**GREATER NEW HAVEN WATER POLLUTION CONTROL AUTHORITY  
CWF 2017-01 CAPACITY UPGRADES AT EAST STREET PUMP STATION  
FOR CSO REDUCTION  
ADDENDUM NO. 1**

**GREATER NEW HAVEN WATER POLLUTION CONTROL AUTHORITY  
CWF 2017-01 CAPACITY UPGRADE AT EAST STREET PUMP STATION  
FOR CSO REDUCTION  
Pre-Bid Conference Agenda**

JUNCTION CHAMBER EQUIPMENT AND PIPING PLAN AND SECTION

DRAWING NO.: M-401

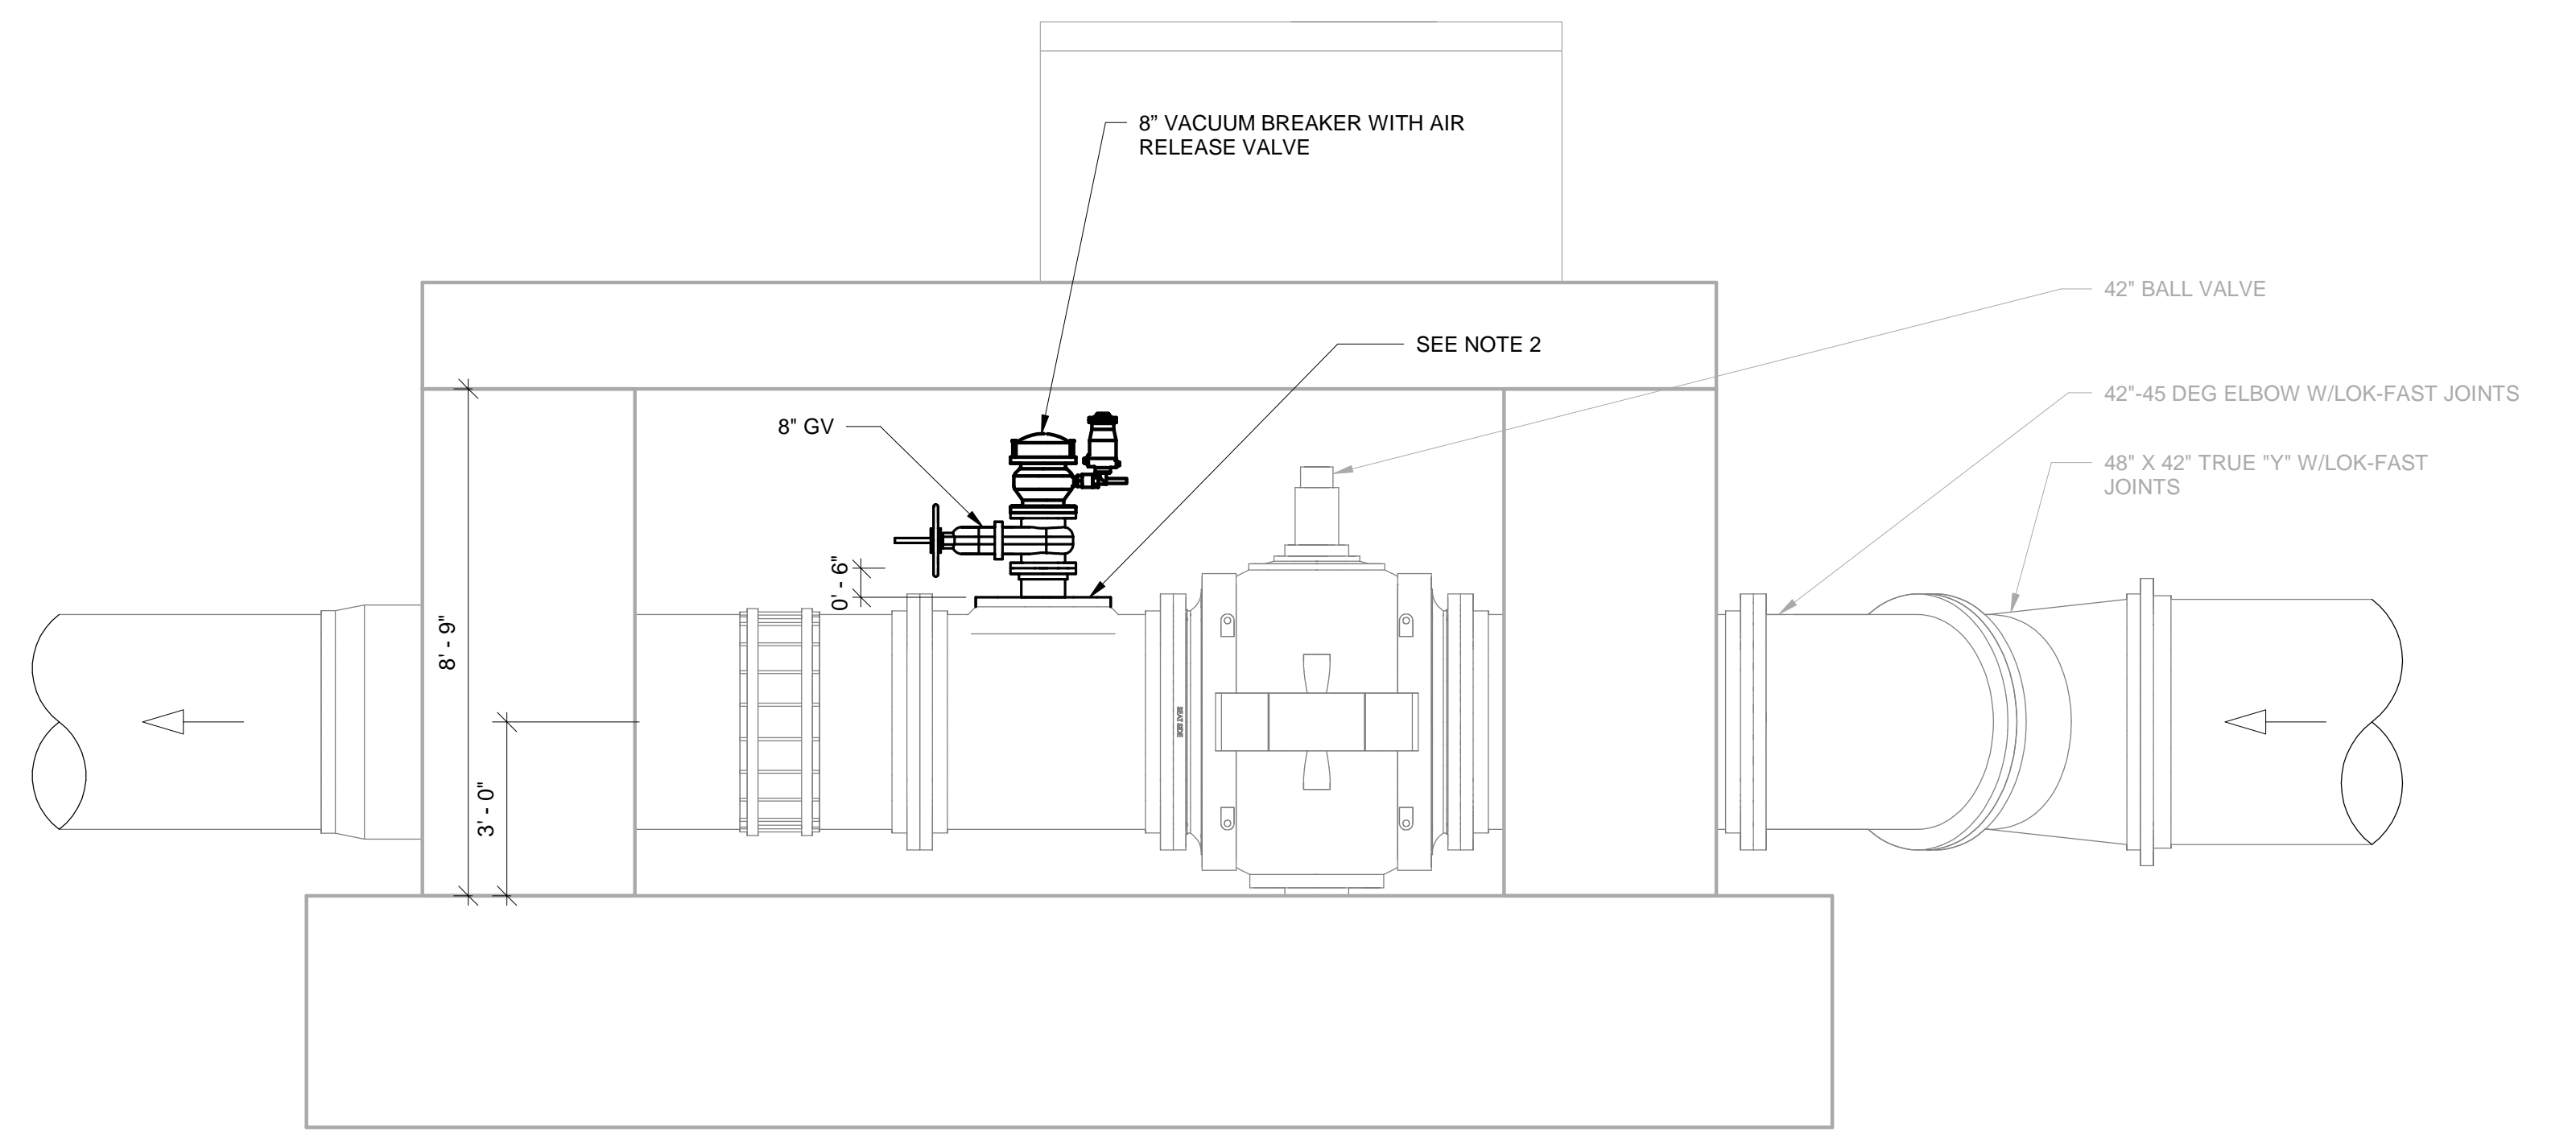
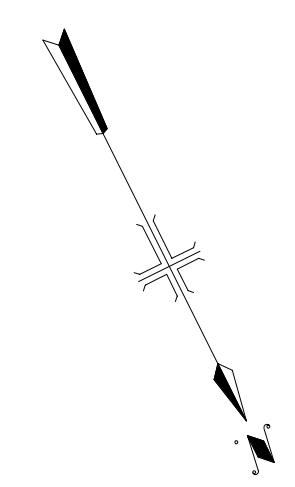
7. Question: Table 01 14 16B- Shut down A – Clarify where this work is shown on the contract drawings.

Response: See new Sheet M-401. Also note that Junction Chamber 3 is on the West Side of the Harbor. Cover Sheet of the Contract Drawings has been updated accordingly.

1. Replace Drawing Cover Sheet (G-001) with attached version.
2. Sheet C-102. Revise the callout note referencing Check Valve Installation to reference Sheet M-701 in lieu of Sheet C-705.
3. Add Sheet M-401 to the set of Contract Drawings as attached to this Addendum.

JUNCTION CHAMBERS  
 DETAILS - PART II

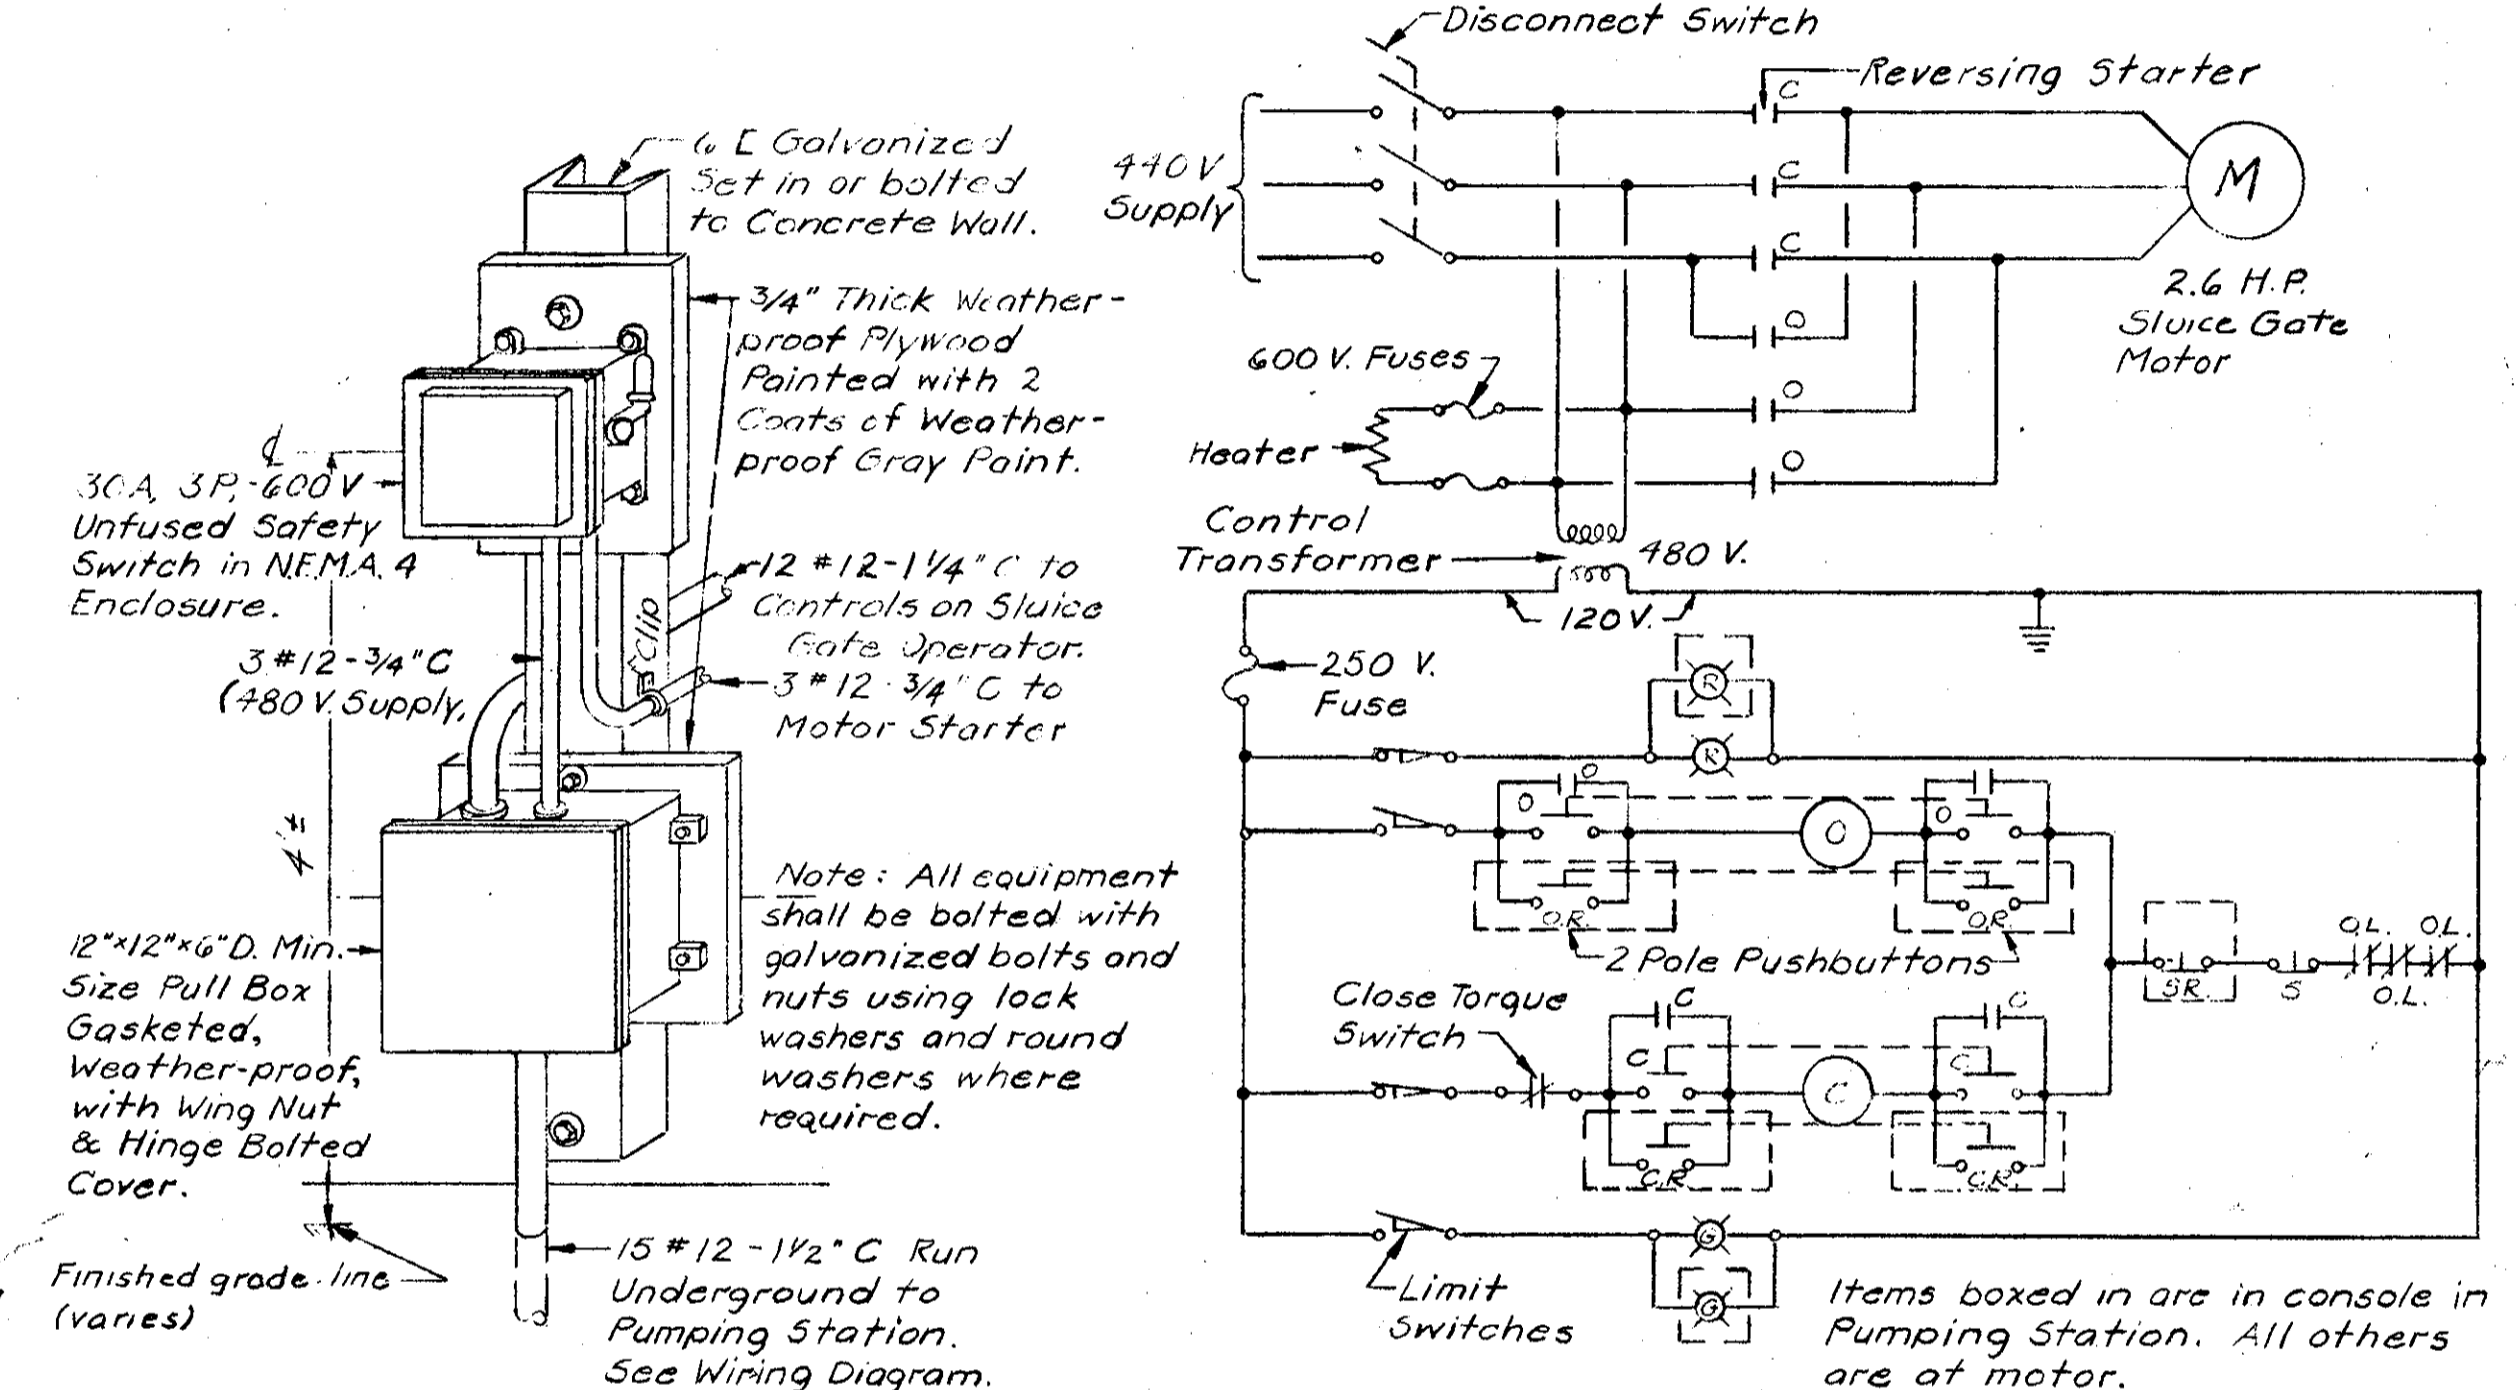
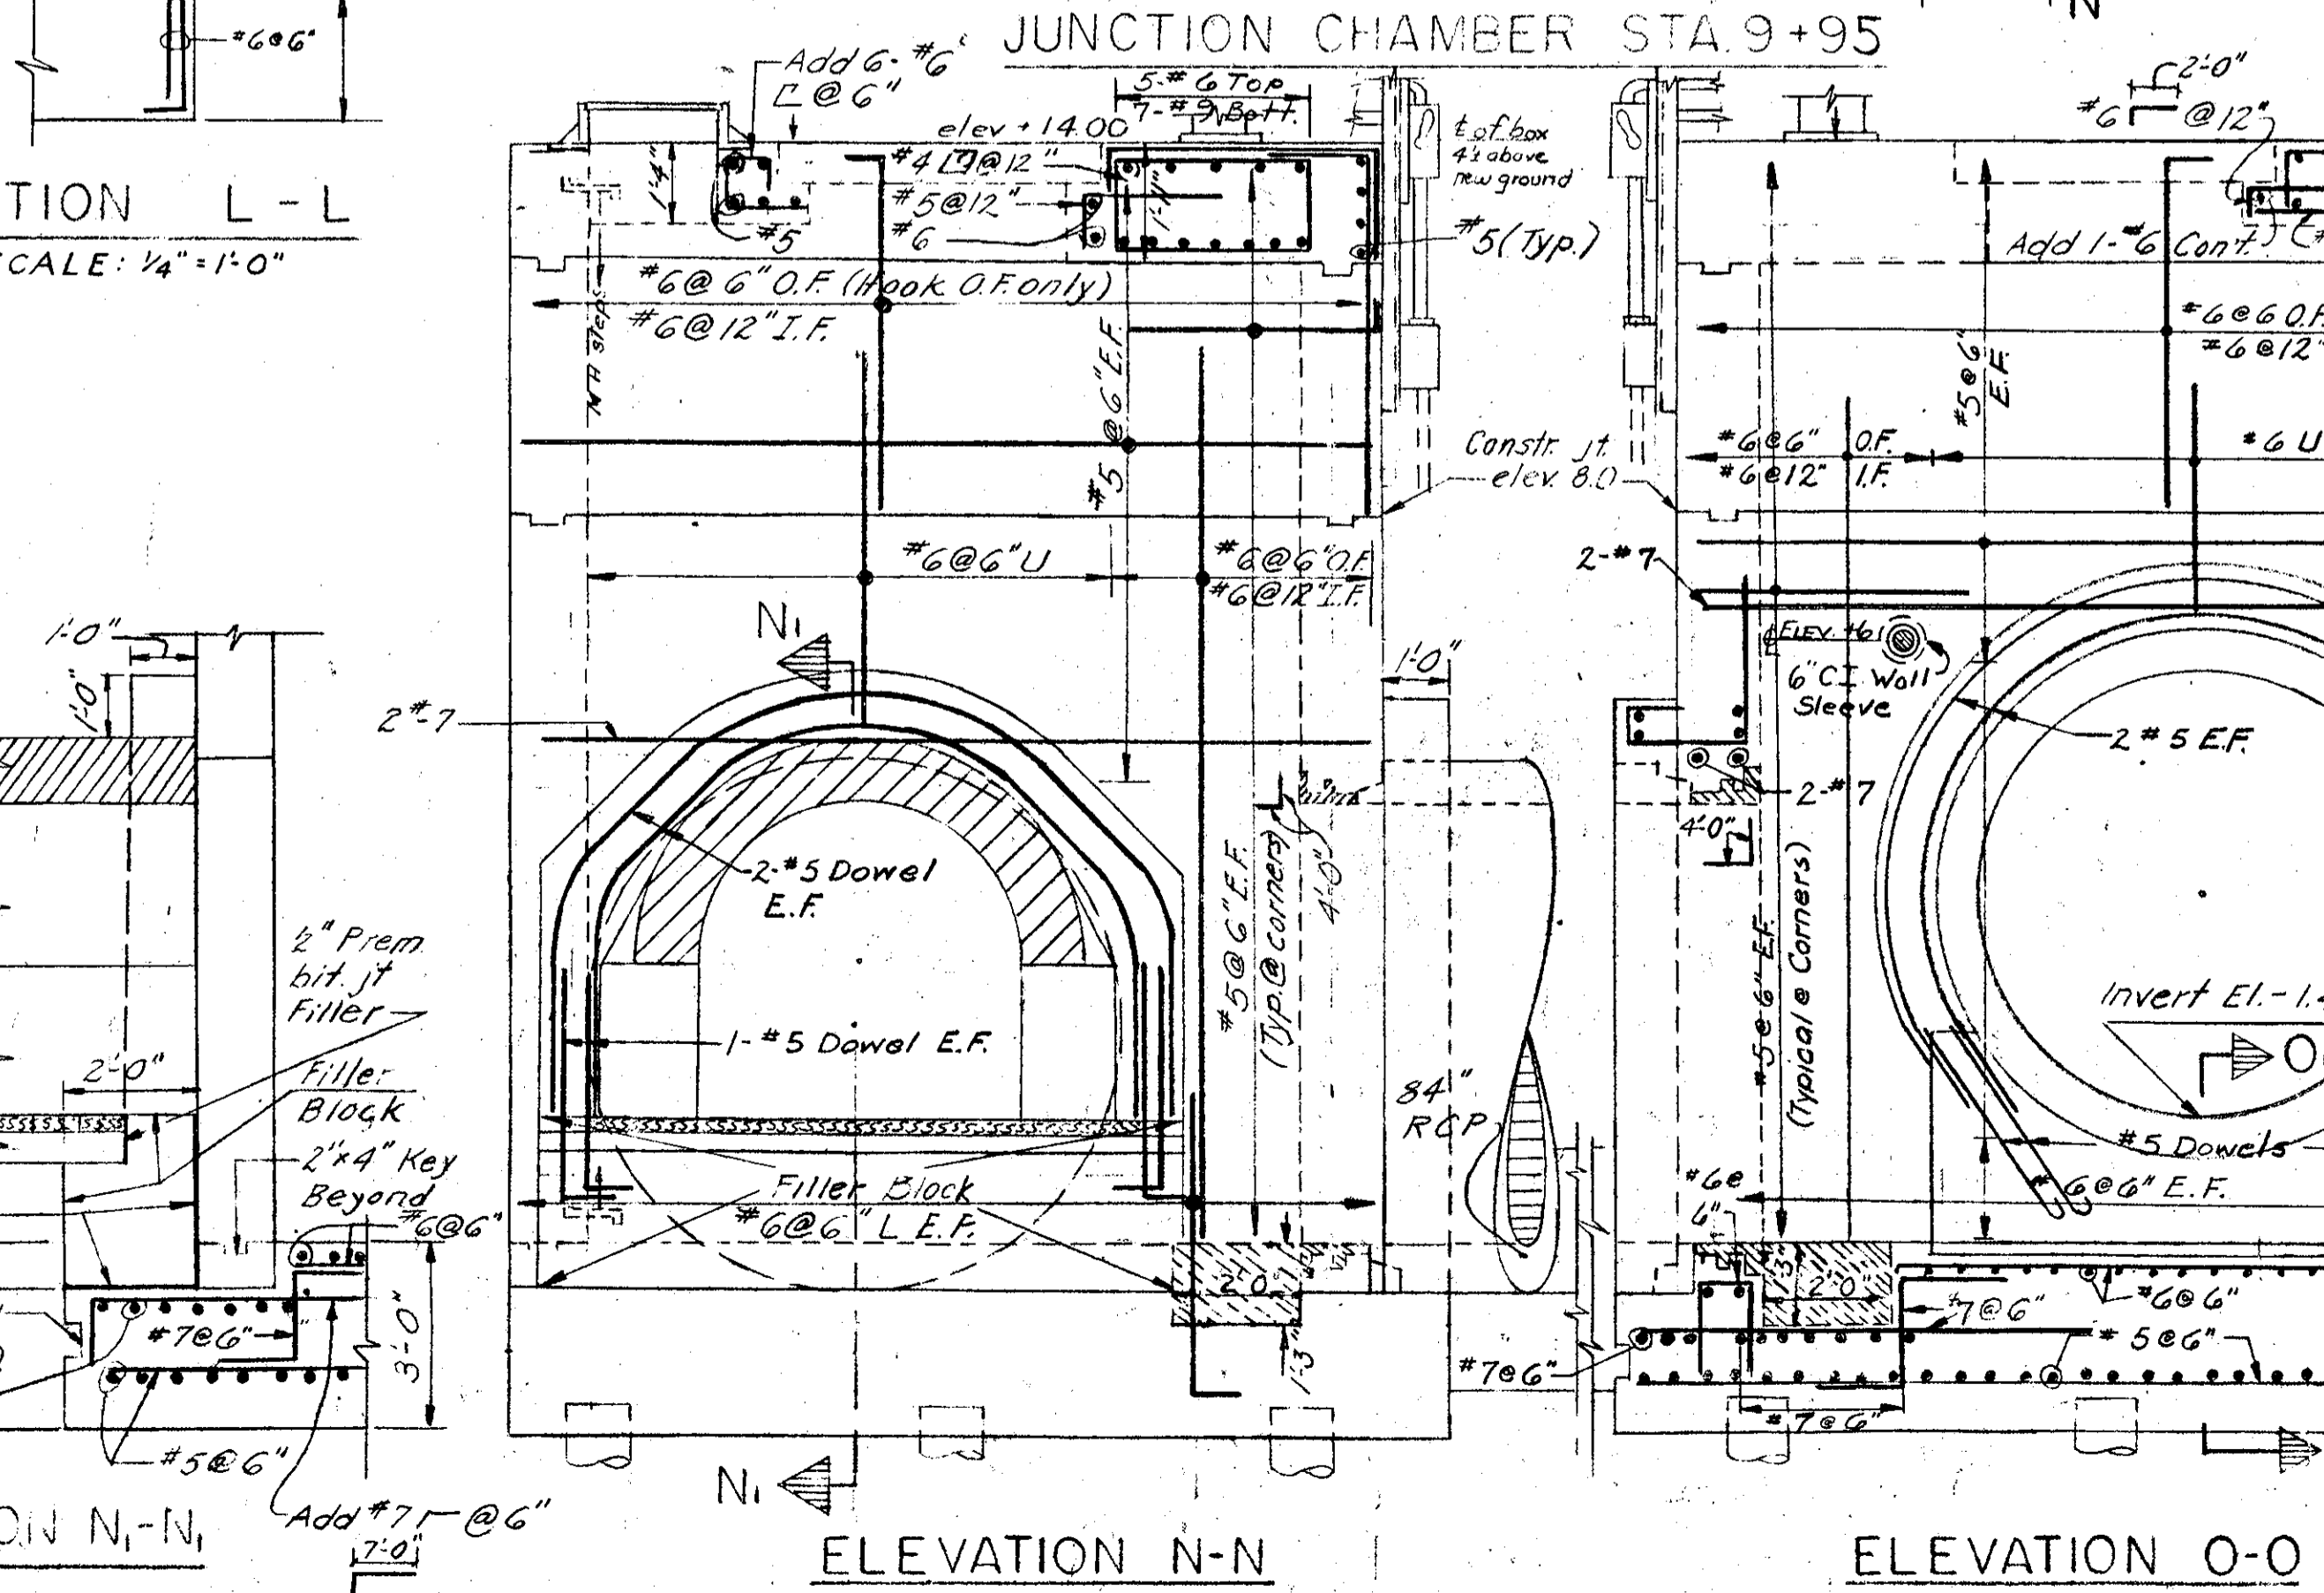
12. Question: Drawing C-101 – Are record drawings of the influent junction chamber available? We are trying to determine if this structure is pile supported.

Response: Available record drawing is provided for reference.
